# **NORTH PARKES MINES STEP CHANGE PROJECT RESPONSE TO SUBMISSIONS**

Part 3A Environmental Assessment

Prepared by  
**Umwelt (Australia) Pty Limited**  
on behalf of  
**Northparkes Mines**

Project Director: **Barbara Crossley**  
Project Manager: **Tim Crosdale**  
Report No. **2949/R16/FINAL**  
Date: **September 2013**

FIGURE 34

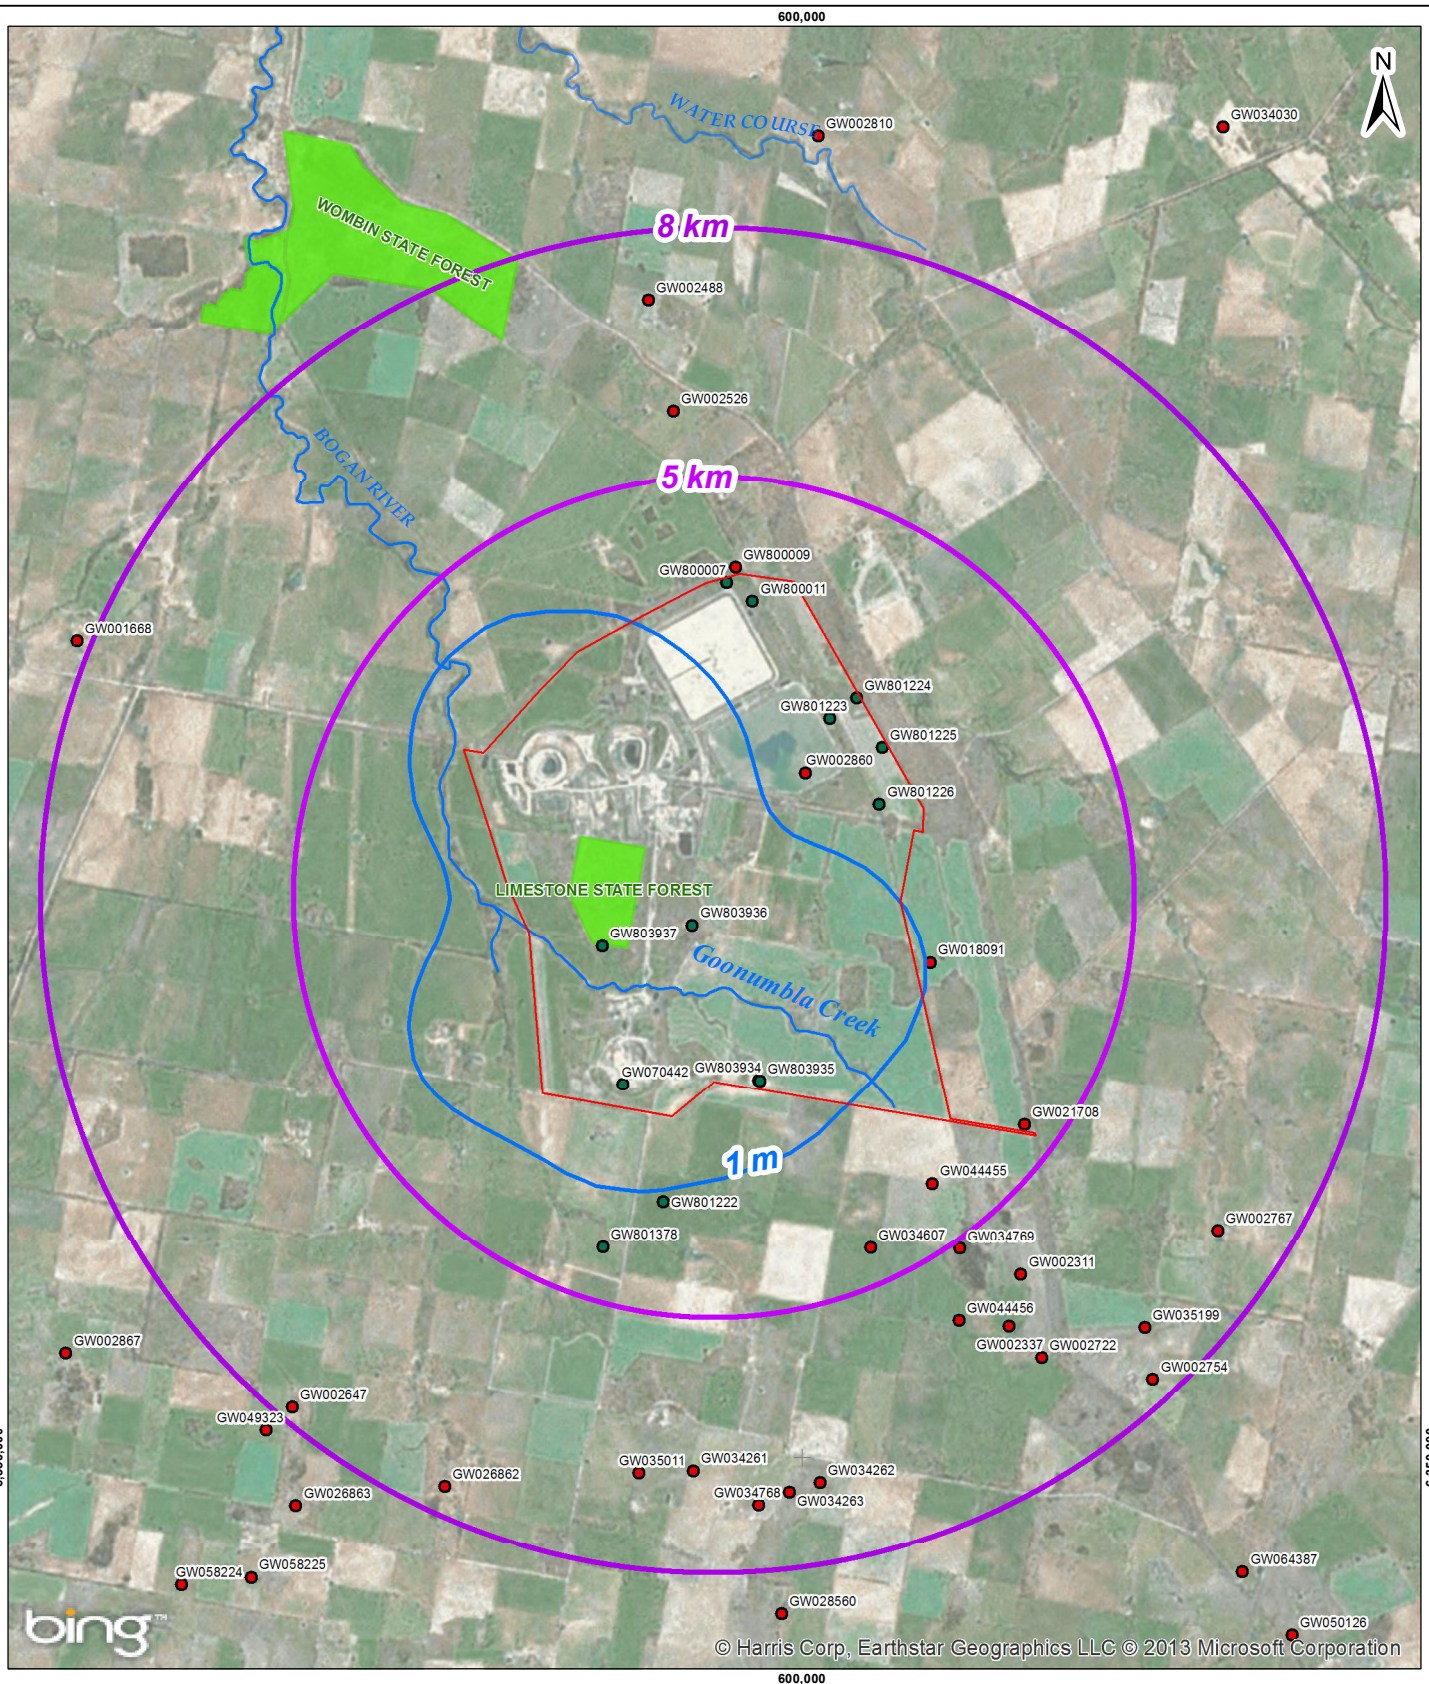
**3(v) Figure 34 referred to in Section 6.3.4 of the Groundwater Assessment (Appendix 10) could not be identified.**

Figure 34 was omitted from our report due to a copying error. A copy is attached.

Figure C8: Observed and computed heads at P149

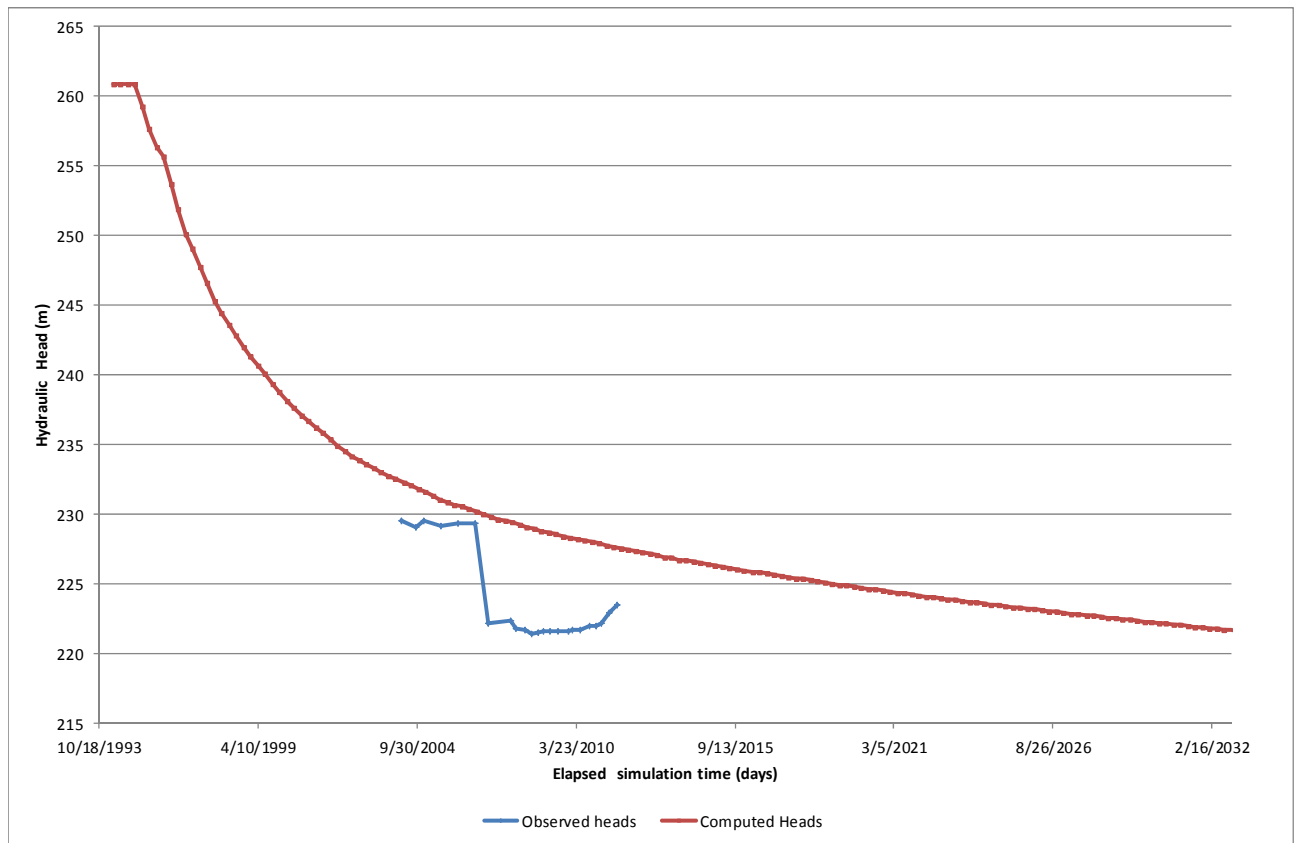
**4(ii) With the exception of monitoring bores W12 to W16, Figure C8 in Appendix C of Appendix 10 shows an overall trend where the computed drawdowns underestimate the measured drawdowns. This indicates the predictive runs presented in the EA may have underestimated impacts to groundwater pressures. It is therefore not possible to accurately determine the maximum impacts to water supply works.**

- There is no record of pre-mining groundwater level monitoring at P149. The groundwater level monitoring data is from 2004 onwards.
- The initial simulated drawdown rate is comparable to the initial observed drawdown rate.

**Figure 10: Monitored Groundwater Levels in the vicinity of the Project Area for Observed Alluvial and Regolith**

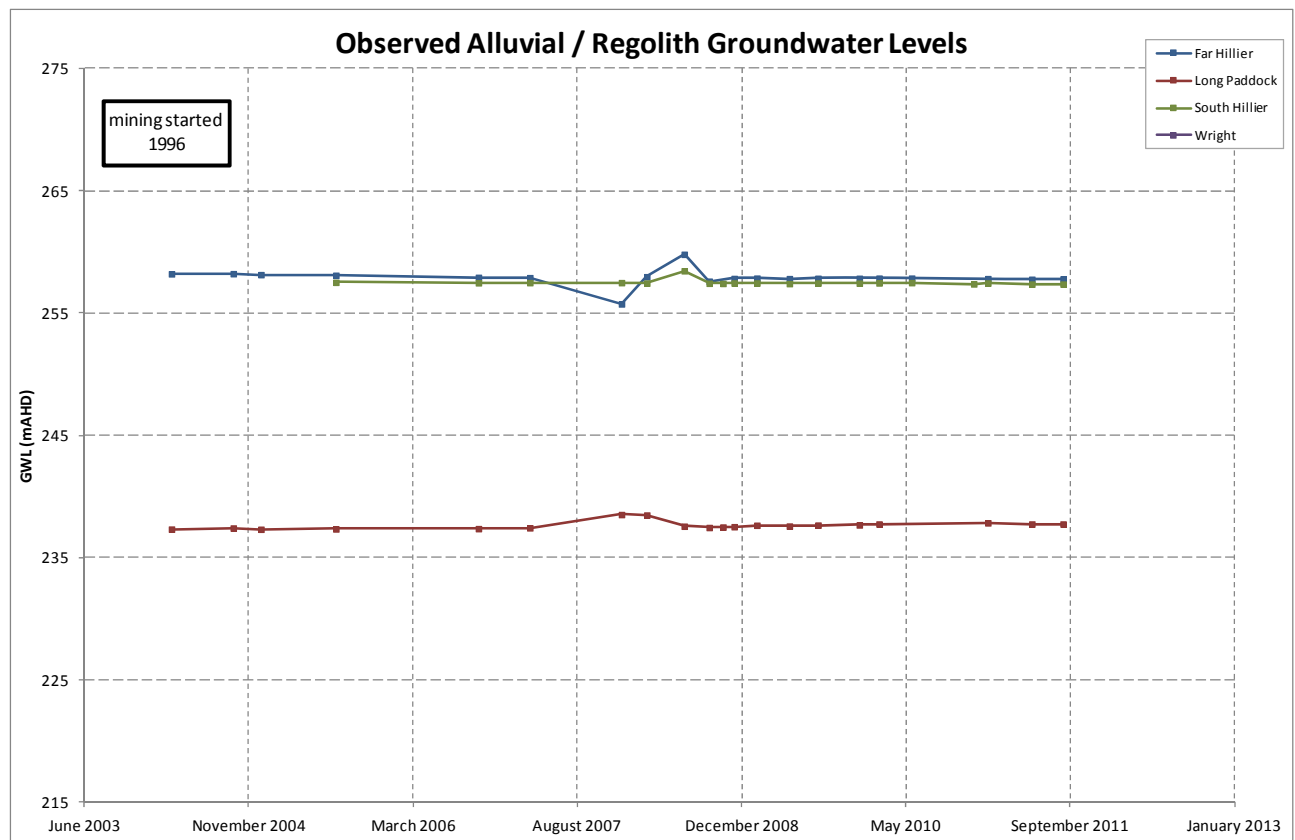
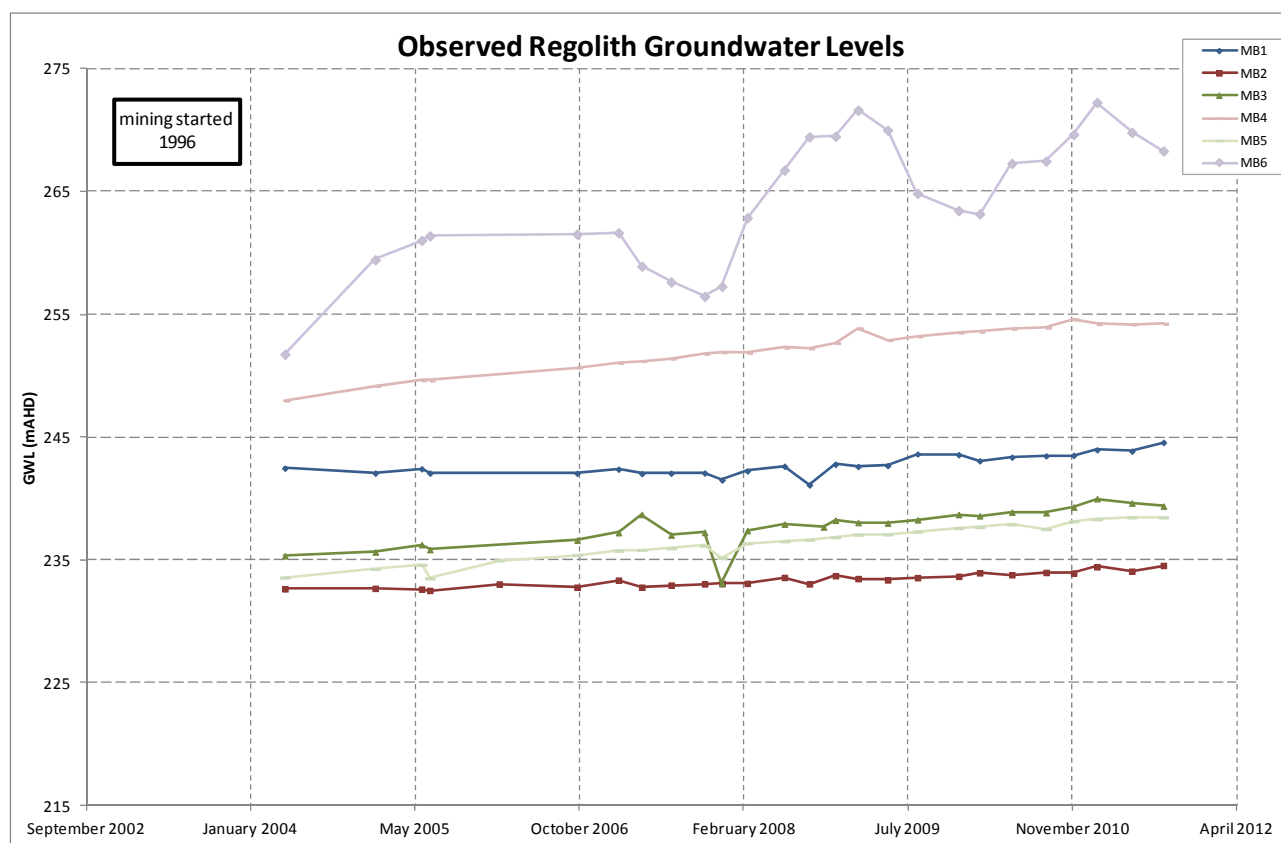
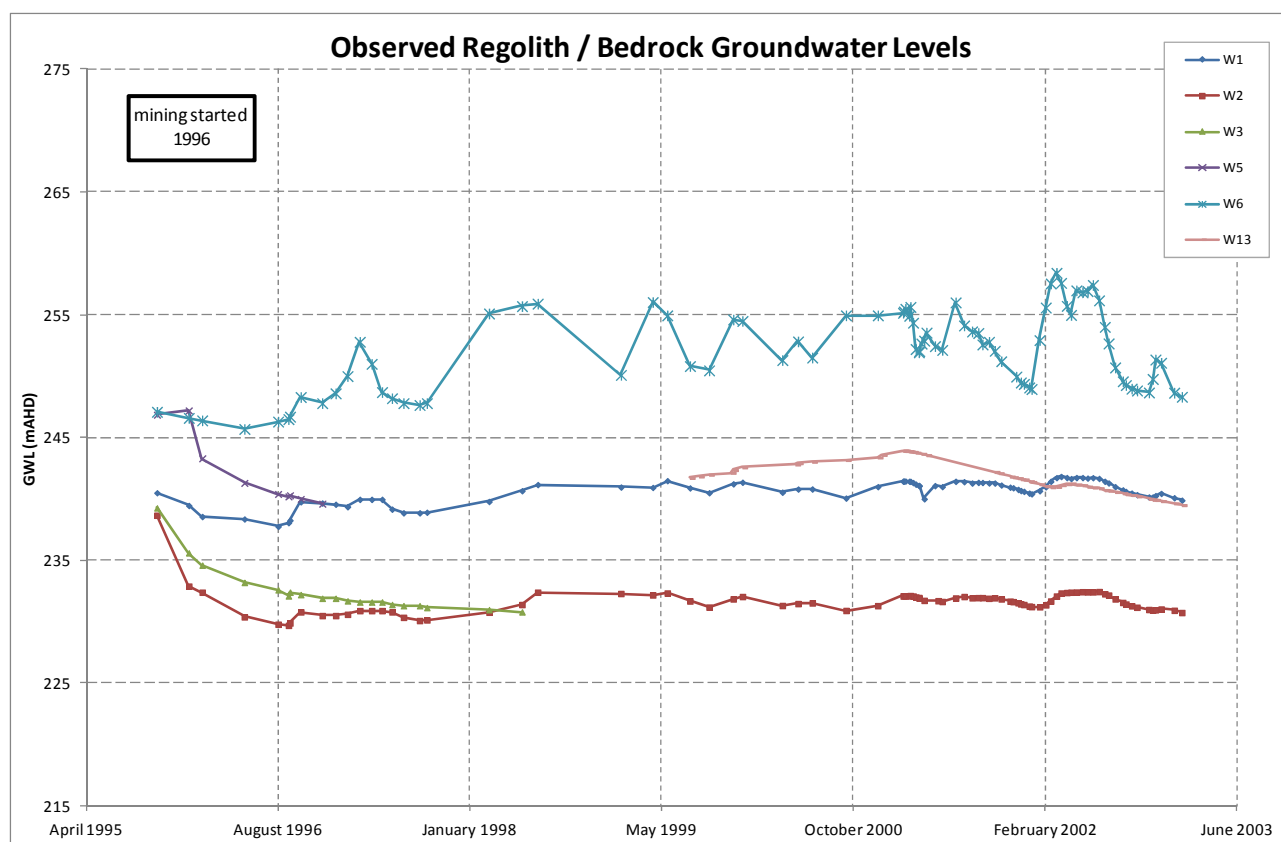
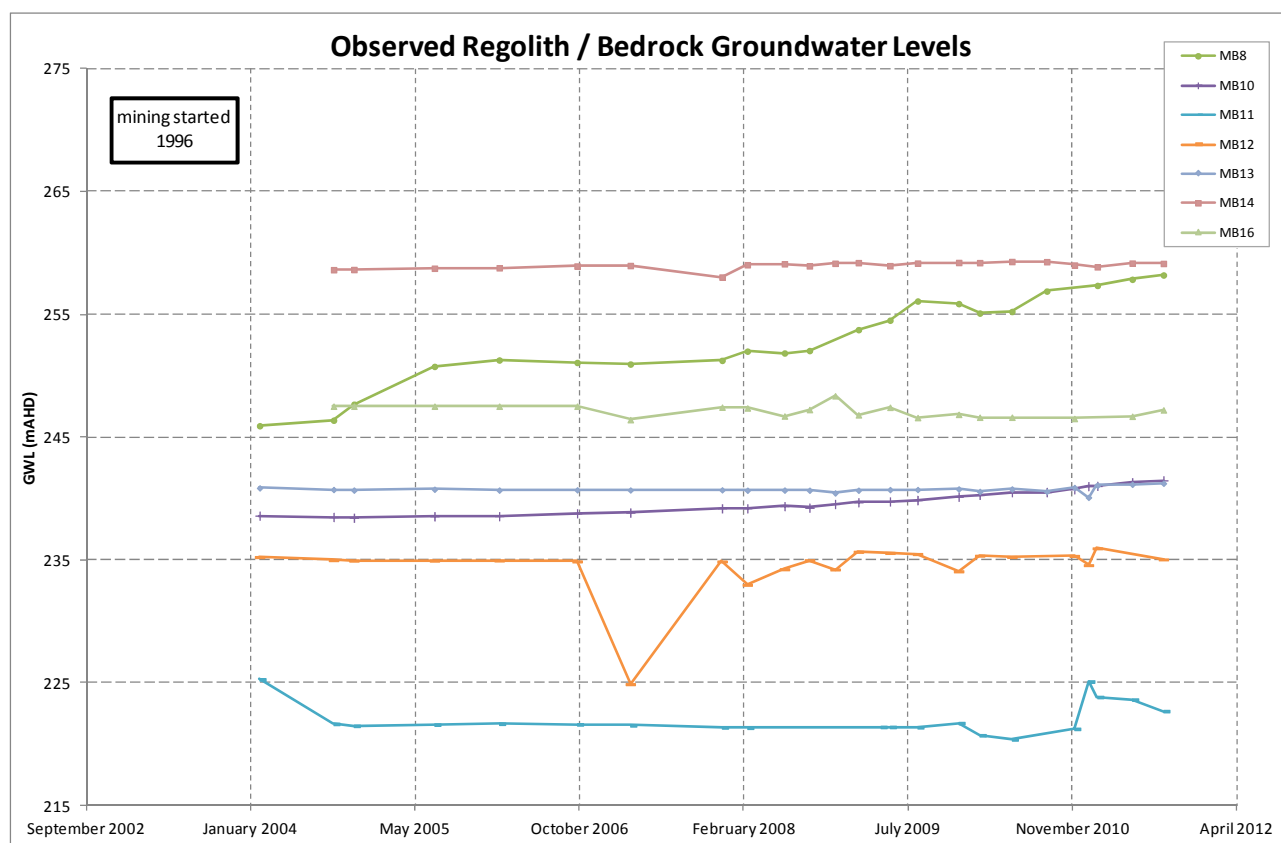
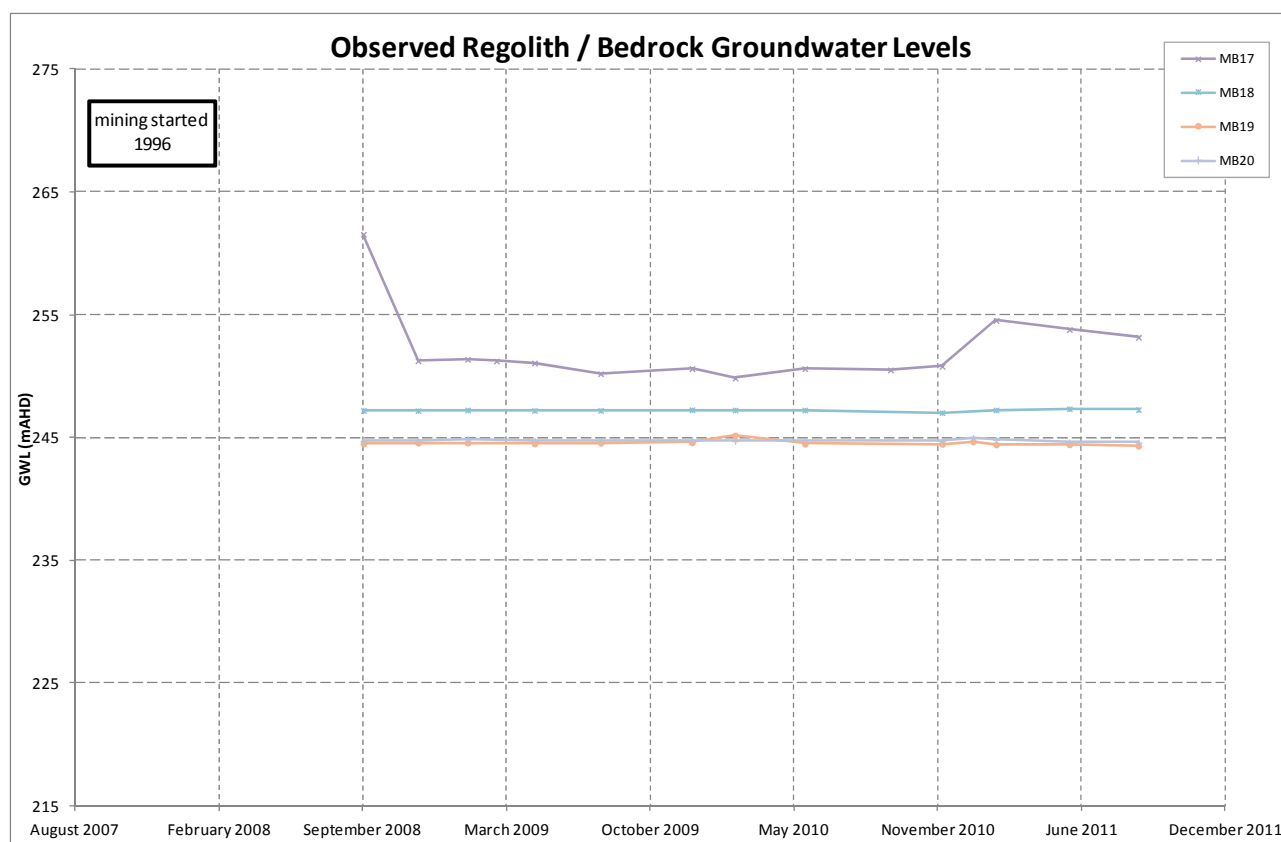
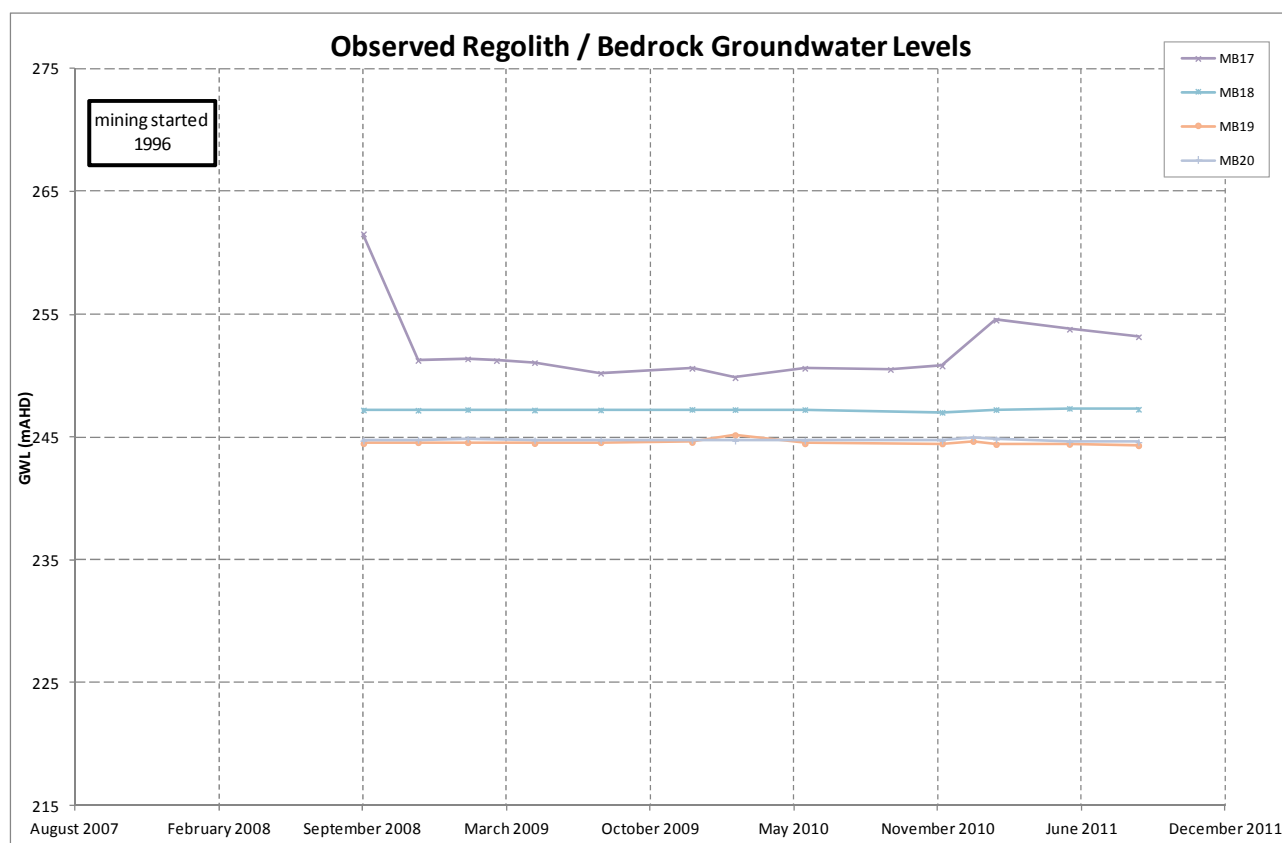
*(iv) Section 4.7 Figures 10, 11, 12, and 13 require adjustment to horizontal 'data' scales to enable hydrograph interpretation. In addition, the asterisk marks on Figures 10, 11 and 13 require explanation.*

We have edited the scales on Figure 10, 11, 12 (a to d) and Figure 13 (a to d) as requested. The asterisks shown on Figures 10 to 13 of the GWIA Report are not relevant and we have removed them from the revised Figures in the memo. Please see Figures 10 to 13d below.
